SERVICE PROCEDURE

G-12509

SUBJECT: SAFETY RECALL

Bendix® ATR-6™ brake valve on certain CE-C and HC bus models and DuraStar®, PayStar®, WorkStar®, TransStar®, 9800, LoneStar®, and ProStar® truck models built 12/02/2010 thru 01/26/2012 with traction control or stability control and registered only in the states of IA, ID, IL, IN, MA, ME, MI, MN, MT, ND, NH, NY, OR, PA, SD, VT, WA, and WI.

FIGURE 1 - BENDIX® ATR-6™ TRACTION RELAY VALVE

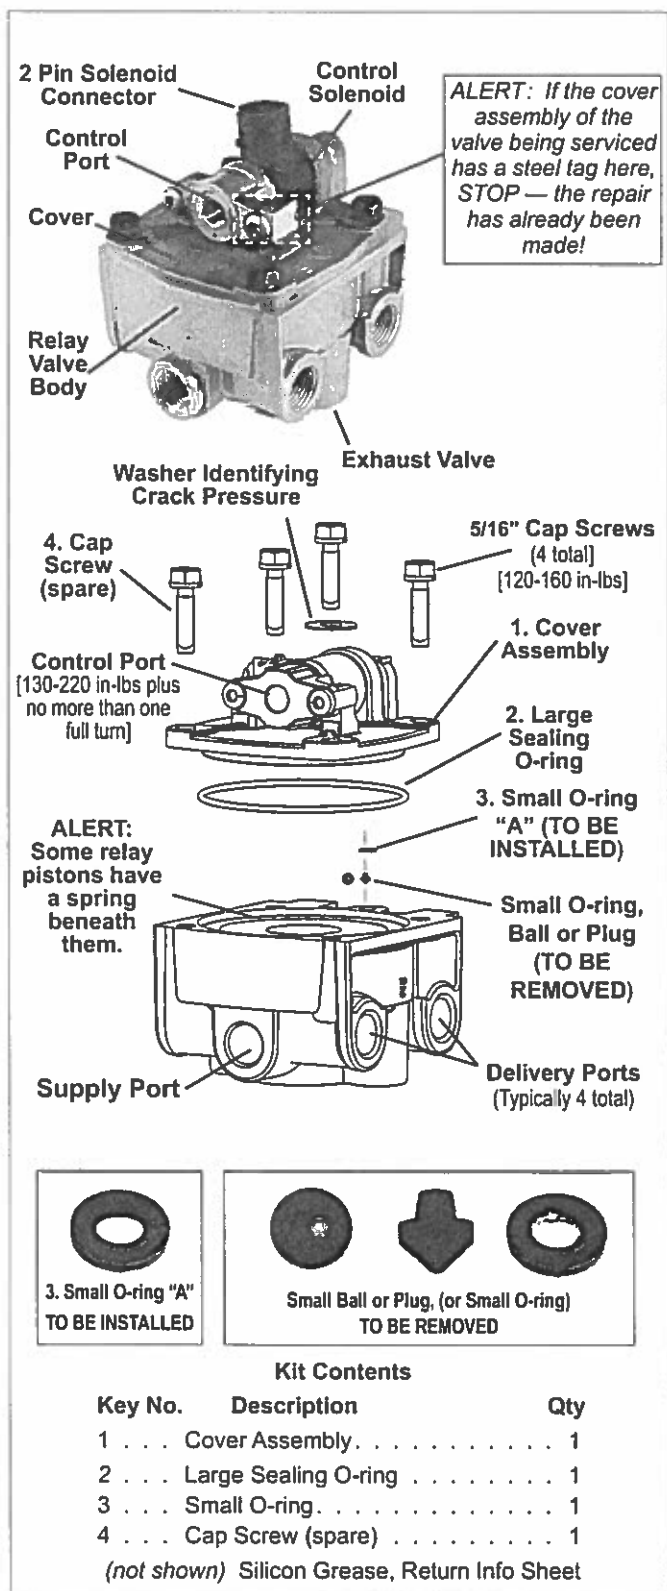
Bendix Commercial Vehicle Systems LLC has determined that a potential defect related to motor vehicle safety exists in Bendix® ATR-6™ valves manufactured between December 02, 2010 and January 18, 2012. In extremely cold conditions (at or below 0° F or -18° C), the Bendix® ATR-6™ valve can experience internal leakage, resulting in air pressure being delivered to the affected service brake circuit and may cause intermittent or, in isolated cases, continuous brake application and registered only in the states of IA, ID, IL, IN, MA, ME, MI, MN, MT, ND, NH, NY, OR, PA, SD, VT, WA, and WI.

1. Verify that the Bendix® ATR-6™ valve does not have a steel tag (See Figure 1) that indicates it has already been serviced.
2. **Clean the valve and take care to avoid any contamination inside the valve during these procedures.**

6. • **Remove and discard the ball or plug ("A" in Figure 1) from between the cover and the valve, OR,**
• **For ATR-6 valves that have not been serviced by a temporary disable kit, there will not be a ball or plug; remove and discard the original small O-ring.**

7. Remove and discard the large sealing O-ring.
8. Grease and install the new large sealing O-ring (2) and the small O-ring (3) supplied, into the NEW valve cover.
